PLANNING COMMISSION MEETING STAFF REPORT

NAME OF PROJECT: La Antiqua Concepts #1 and #2

AGENDA ITEM: Concept Plan Review

LOCATION OF ITEM: 850 East Main Street

Exhibit 1

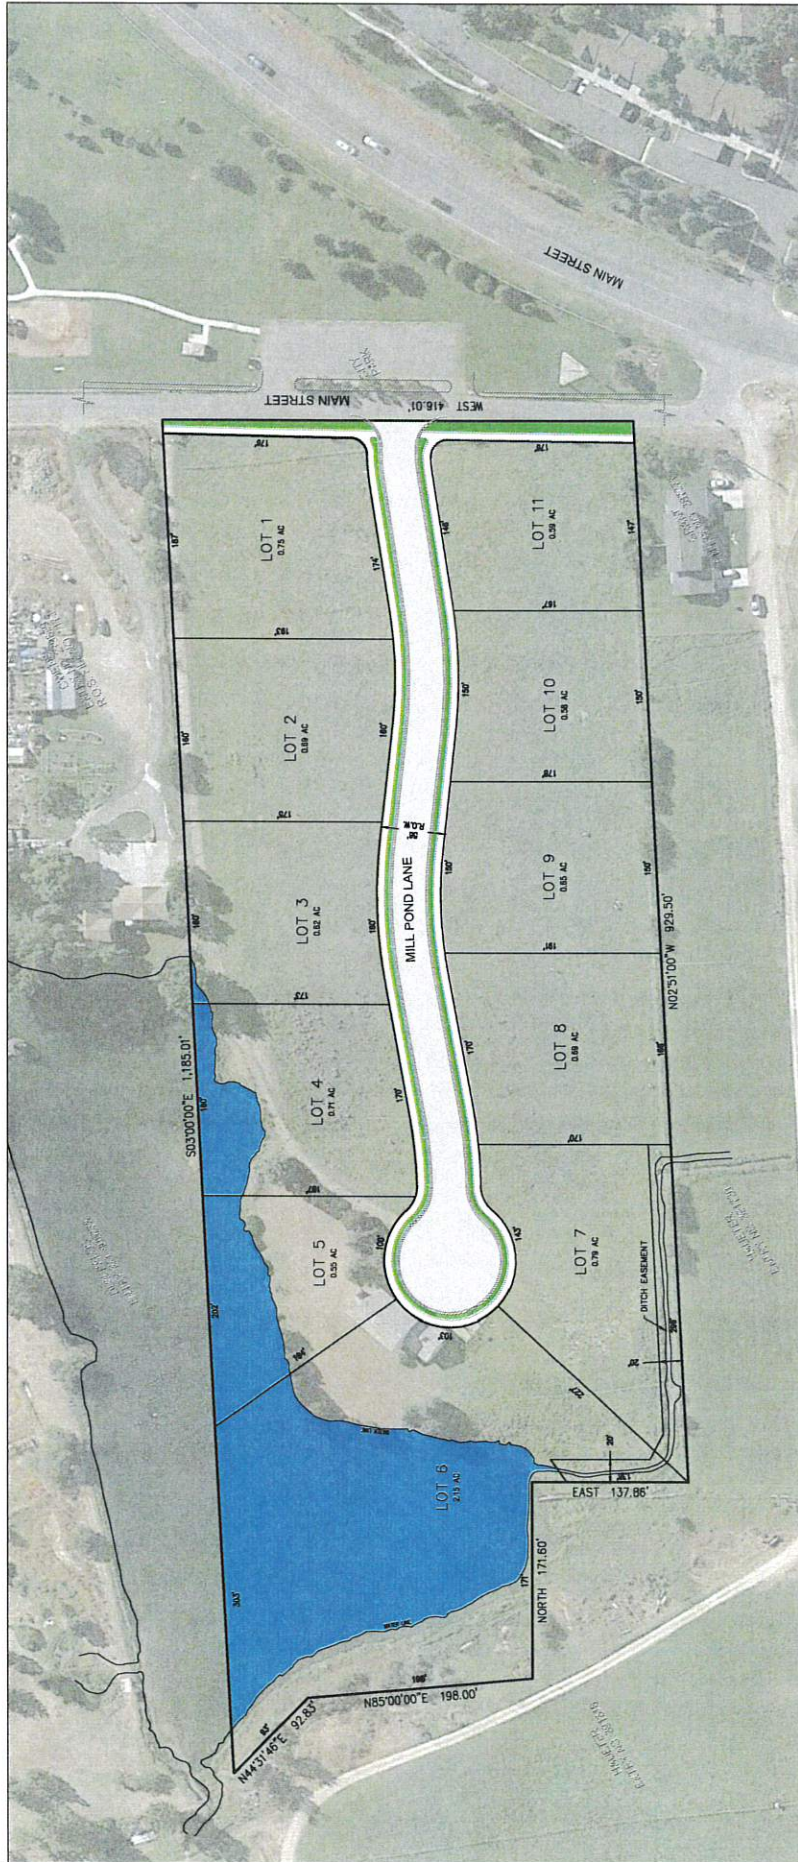
on the north end of the property. The pond is partially located on the applicant's property. The remaining portion is located on the Johnson Mill property. The major difference between the two concepts is that concept plan #1 includes common area which includes the pond, private park, and landscaped area at entrance to development. Concept plan #2 is more of a traditional subdivision and does not include any common space. In this concept there is no park, and the pond area is split between four different lots.

Standard subdivisions greater than 10 acres in size are required to provide a minimum of 15% open space, which equates to a minimum of 1.55-acres for this proposal. Sensitive lands can count towards the open space as outlined in the land use code. When the applicant applies for preliminary approval, they will need to identify which lands count towards their open space. Concept plan #1 has a 3.15-acre common space parcel that includes the pond and a private park that could count towards the open space requirement. The open space/park would be privately owned, it would not be deeded to the city as a public park. Concept plan #2 does not include any common space but has incorporated the pond area into the private lots. Currently the land use code allows for open space to be within a private lot, if the lot is 2 acres or larger. Lot 6 could possibly satisfy the open space requirement, but the required open space should be identified and noted as unbuildable. Proposed uses for the open space need to be in harmony with the intent of open space as listed in the land use code.
